**SUPPLEMENTAL / BID BULLETIN No. 2019-038-02**

**Subject: "Supply, Delivery, Installation, Commissioning, Testing and Training of Hydro-Meteorological Rainfall and Water Level Telemetry Monitoring System Equipment for the Aklan River Flood Forecasting and Warning System;" (Reference: PR No. 2019-04-0265 / IB No. 2019-038; ABC Php16,302,480.00)**

## HYDROMET TANDEM SENSOR

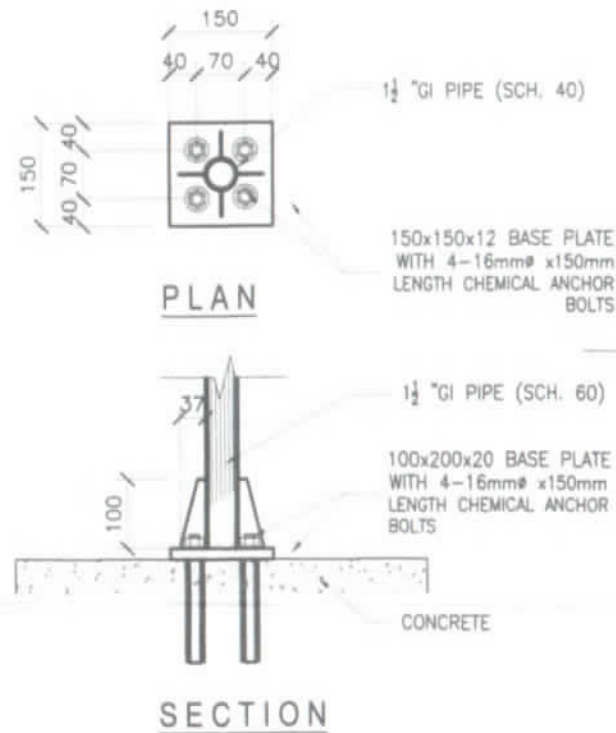
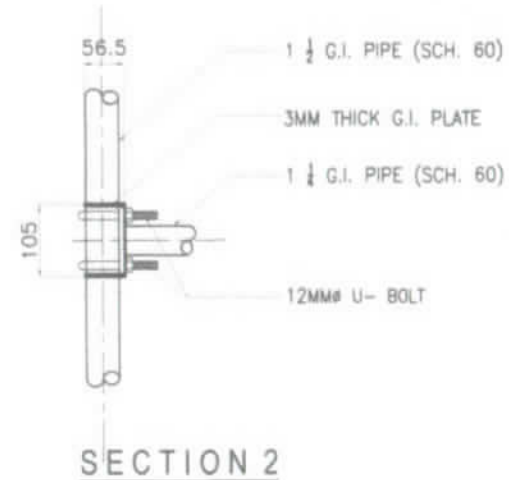
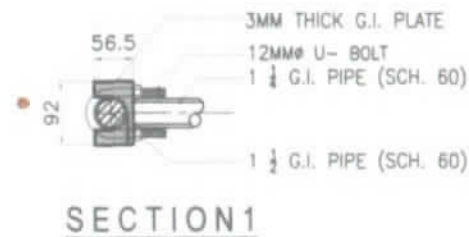
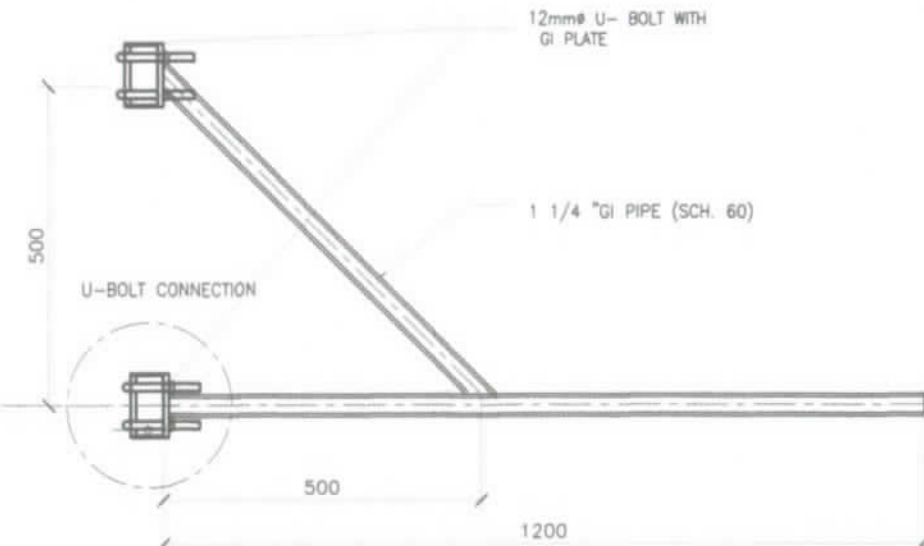
7. Under the terms of reference item G Schedule of Requirements item C summary of deliverable equipment specifies that a "galvanized monopole antenna mast with steps, guy wires, and turnbuckles, brackets and lightning protection," may we request for a typical drawing of the prescribed mast.	<p>The typical design for the monopole antenna mast is provided herewith as <b>Annex "A."</b></p> <p>The height of the antenna mast may vary based on the actual requirement of each site; however, for purposes of this bid and uniformity in the offer the height indicated in the drawing shall be followed.</p>

STAFF GAUGE

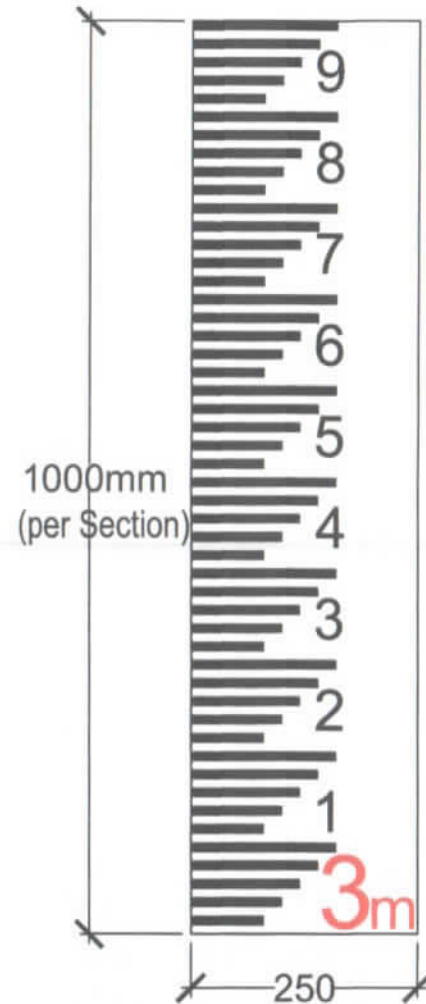
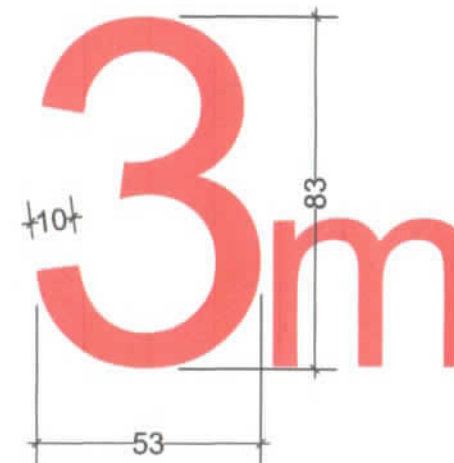
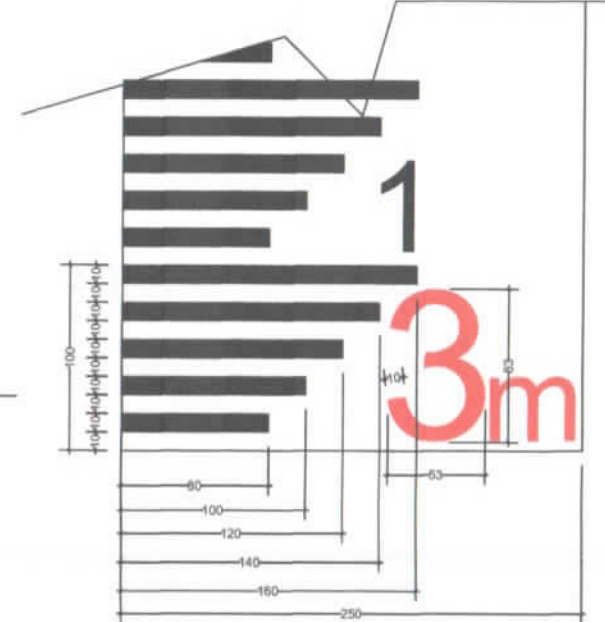
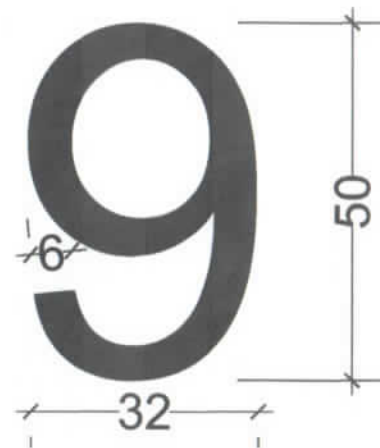
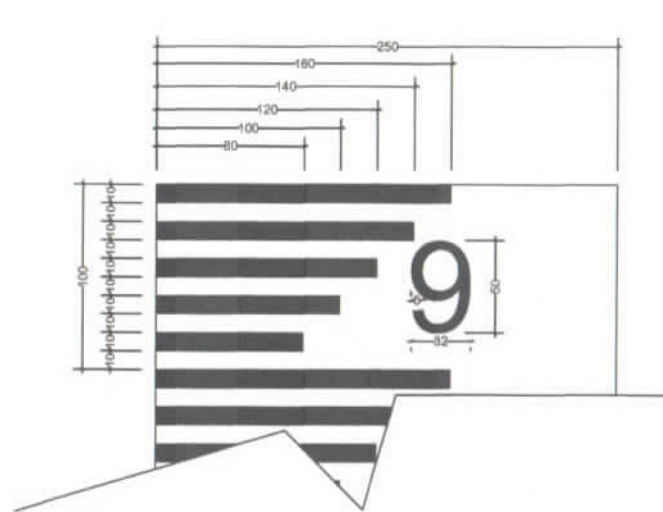
9. Under the terms of reference item H Technical Specifications item 12 staff gauge, please provide a typical drawing for this item	The typical drawing for the Staff Gauge is hereto attached as <b>Annex "B"</b> .

ANNEX C

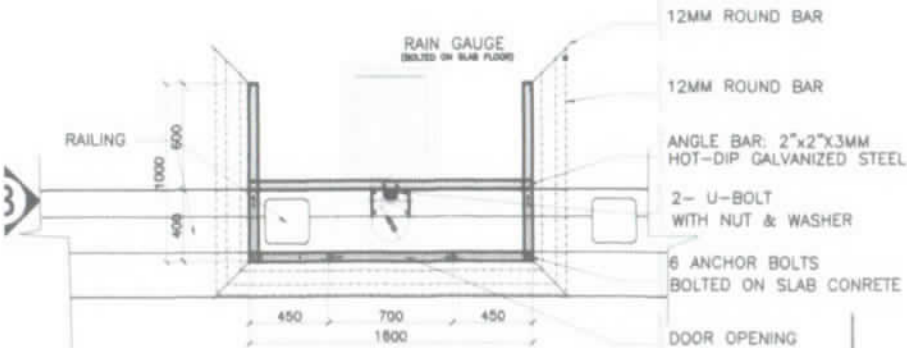
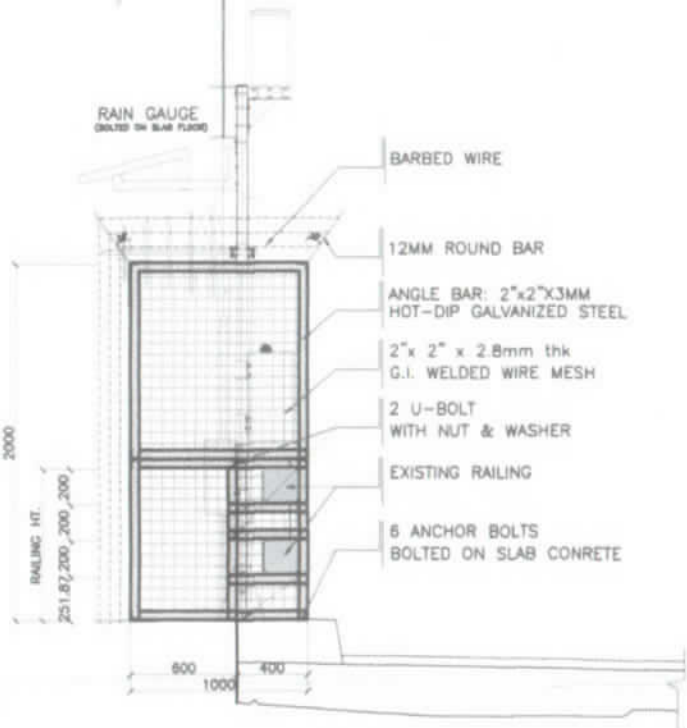
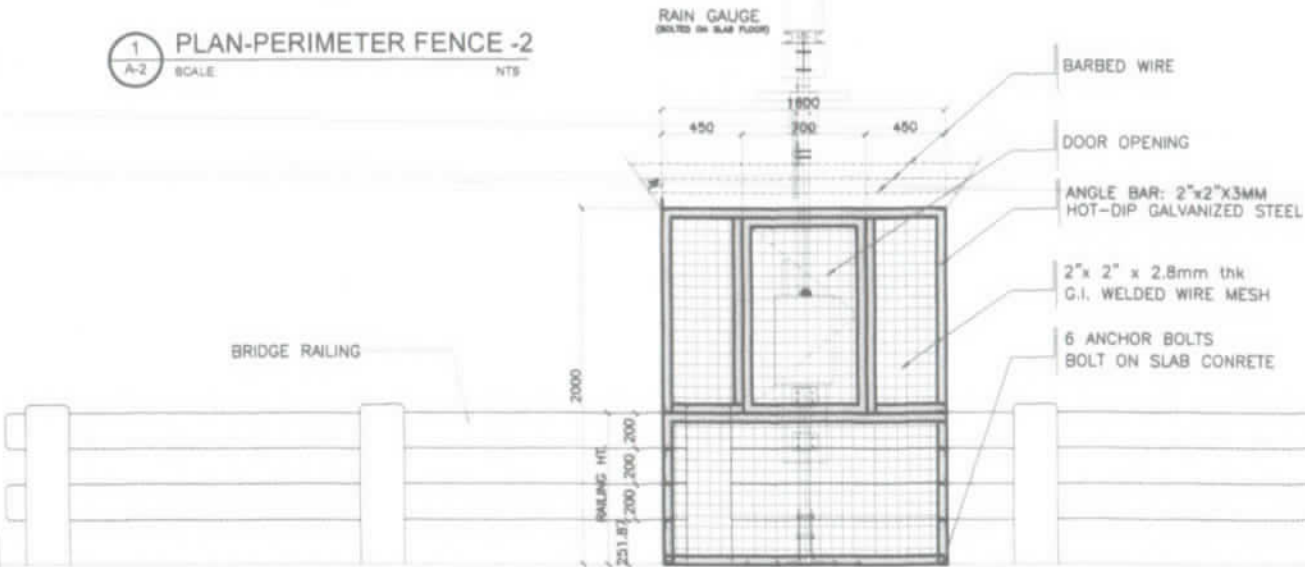
10. Under the terms of reference item H Technical Specifications item 13 security fence and signage, please provide a typical drawing for this item;	The typical drawing for the security fence and sample signage are attached herewith as <b>Annexes "C" and "D"</b> , respectively.
